CALL NO. 302  
CONTRACT ID NO. 261512  
ADDENDUM # 1

Subject: LAUREL COUNTY FD06/FD59 063 0025 009-011  
Letting July 23, 2026

1. Revised Proposal Bid Items p. 313-322 of 322  
Removed 14031 W Meter Vault 1 EA
2. Revised Plan Sheets: R2R, R77, U5, U10, U31, U32, U44, U46, U48, U59,  
U72, U74, U79, U96, U103, U106, U108, U109

COMMERCIAL DRIVE  
STA. 54+00 TO STA. 60+00  
PLAN SHEET

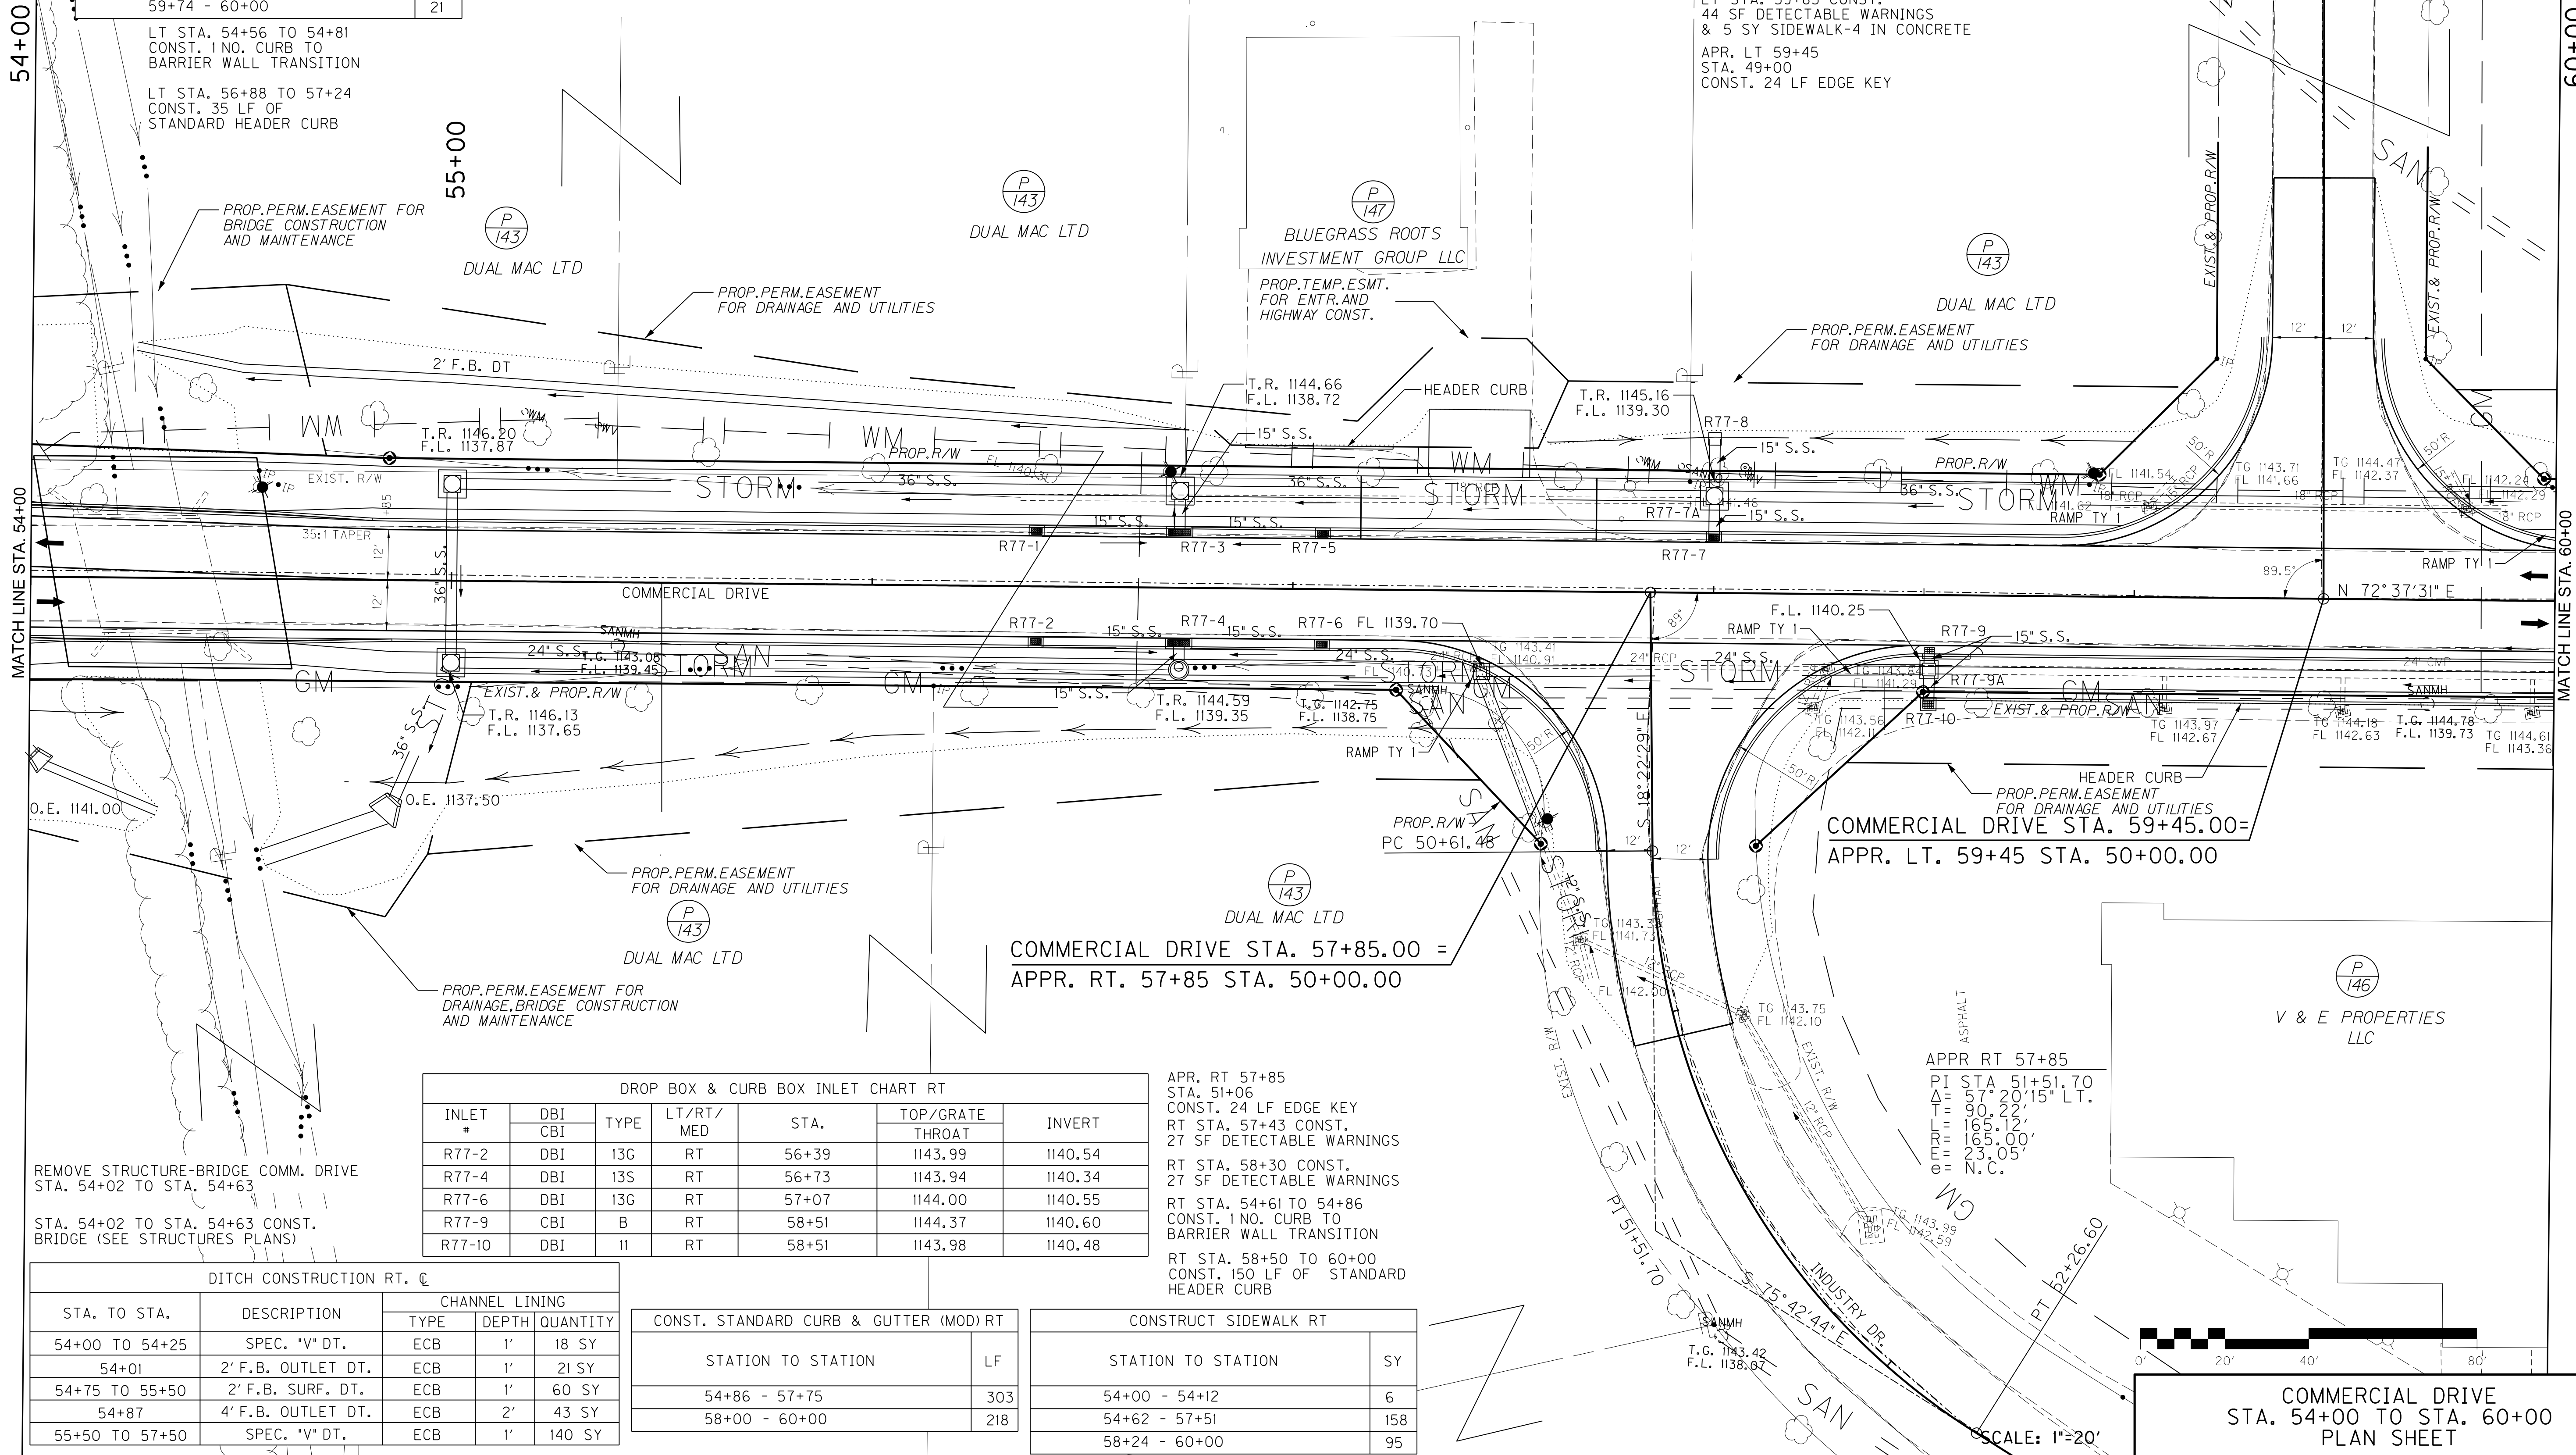
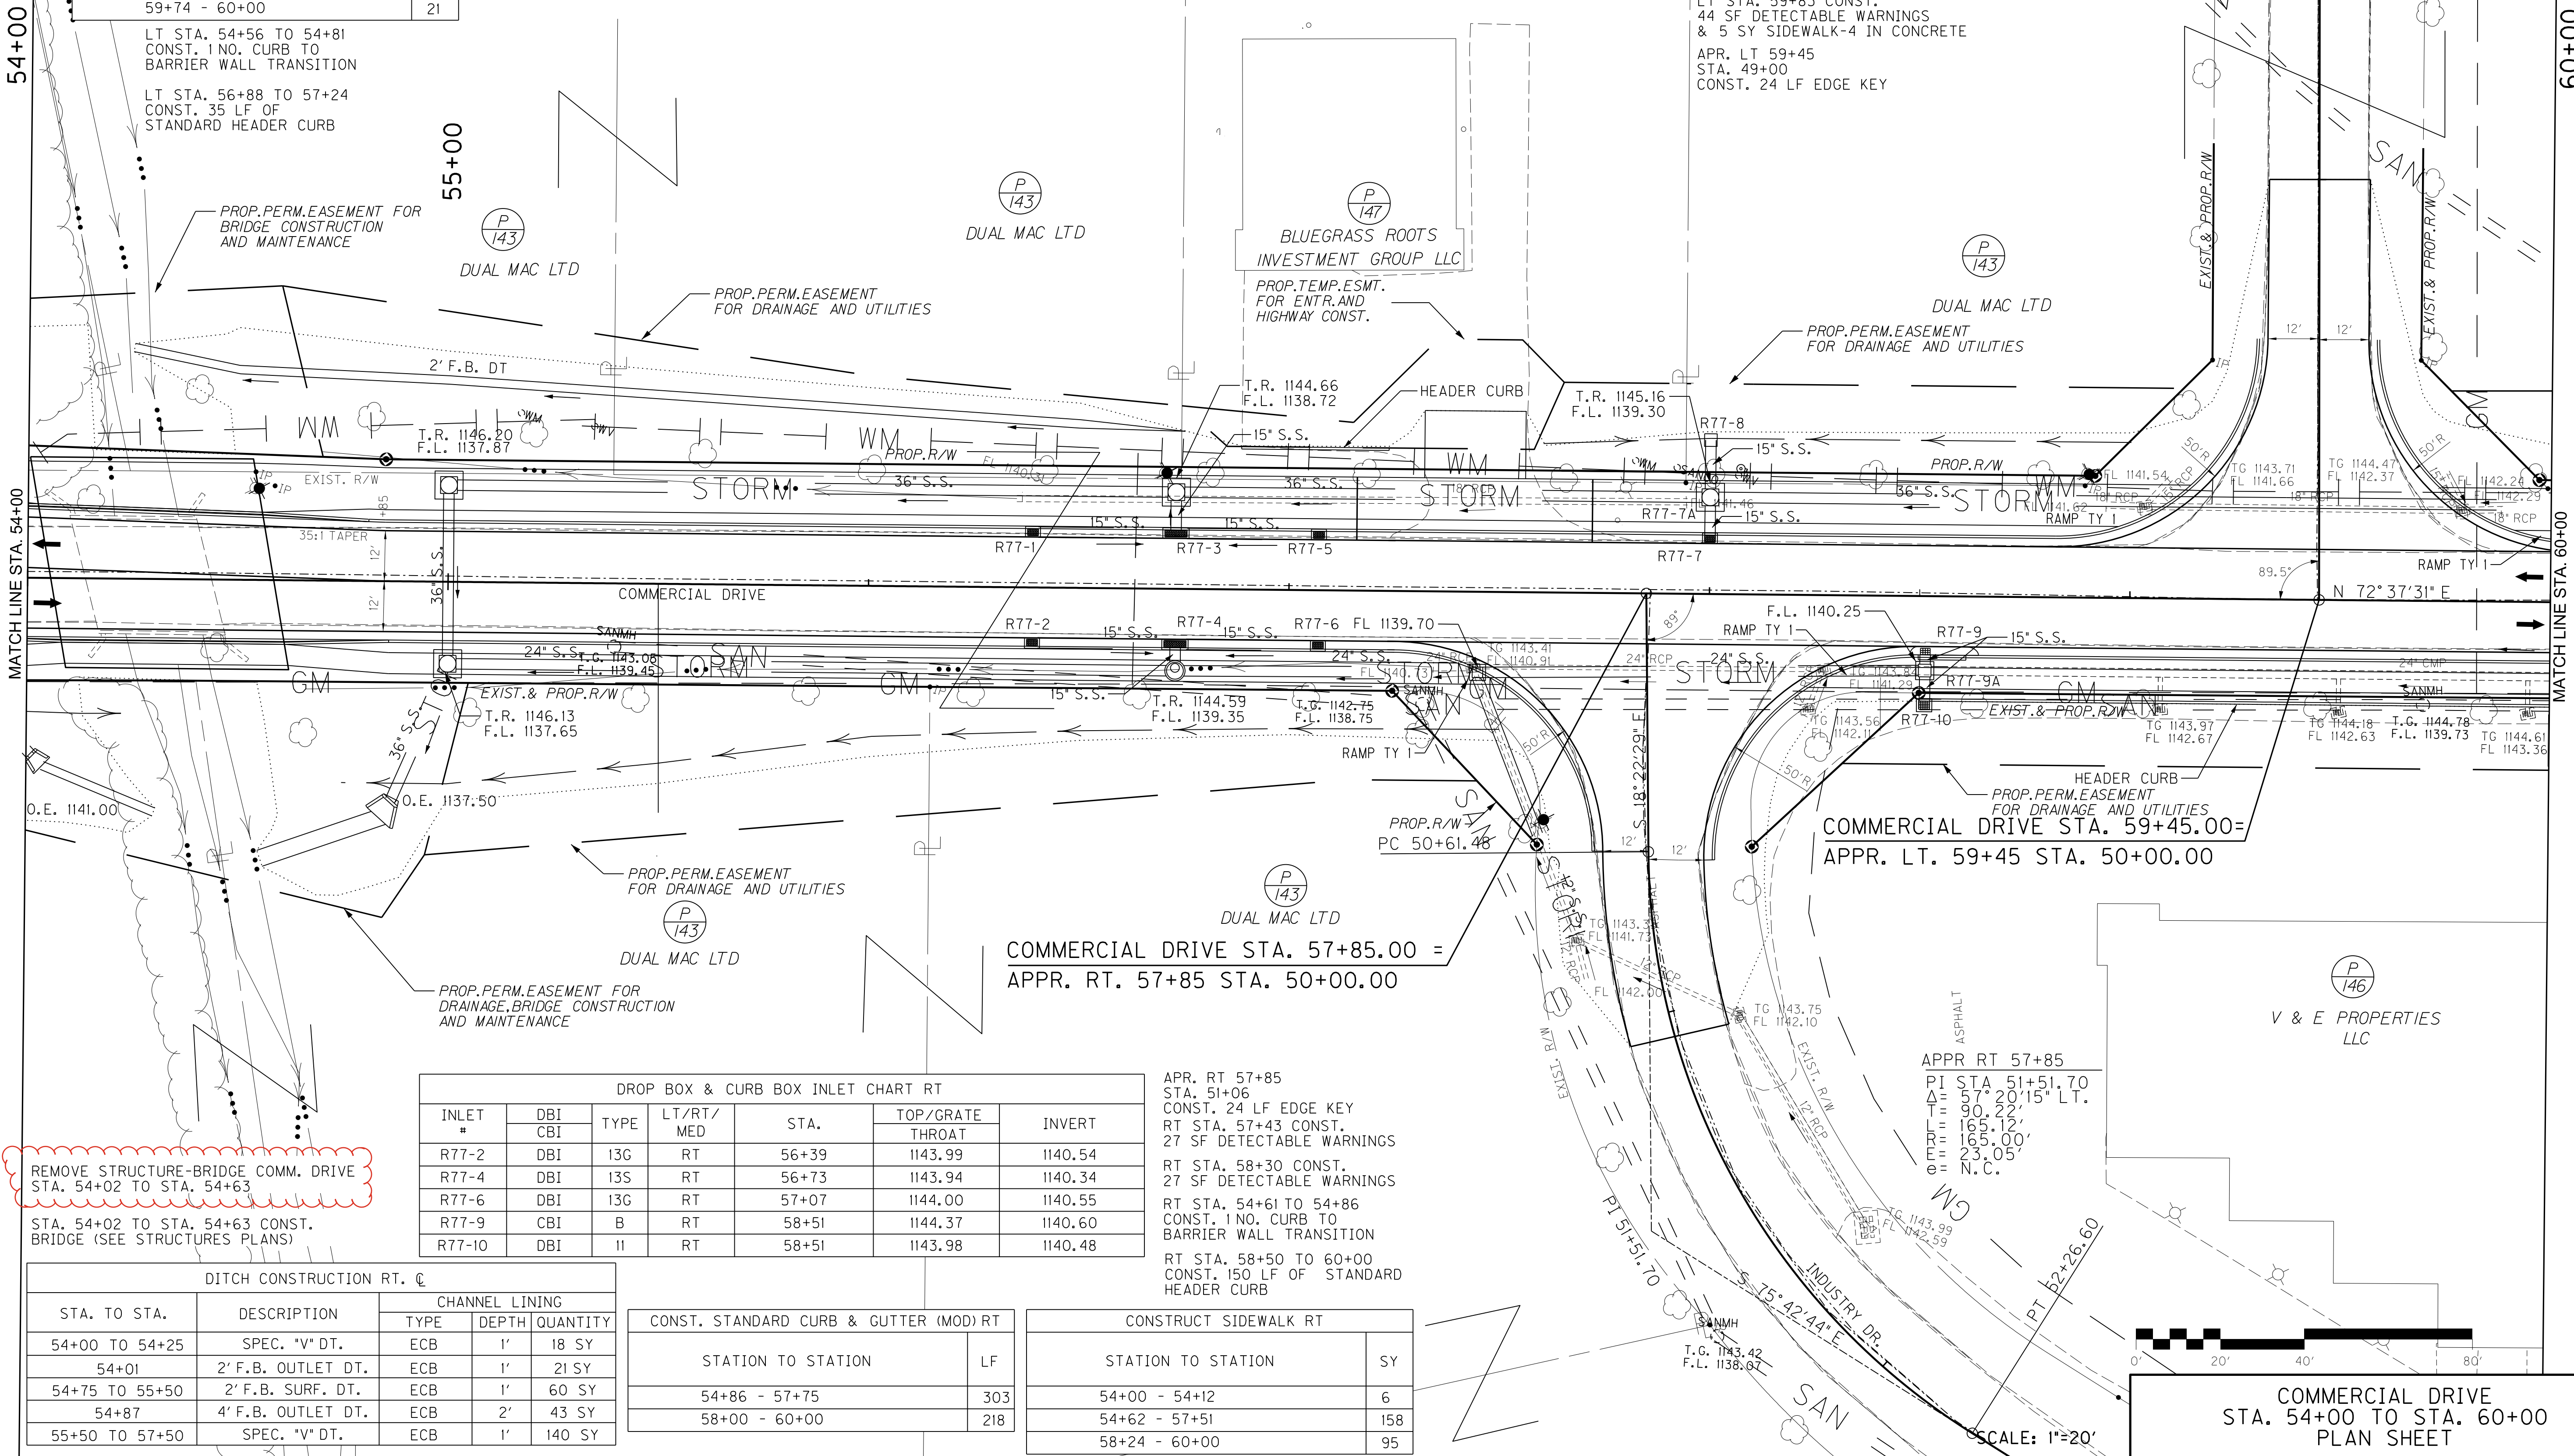
REMOVE STRUCTURE-BRIDGE COMM. DRIVE  
STA. 54+02 TO STA. 54+63

STA. 54+02 TO STA. 54+63 CONST.  
BRIDGE (SEE STRUCTURES PLANS)
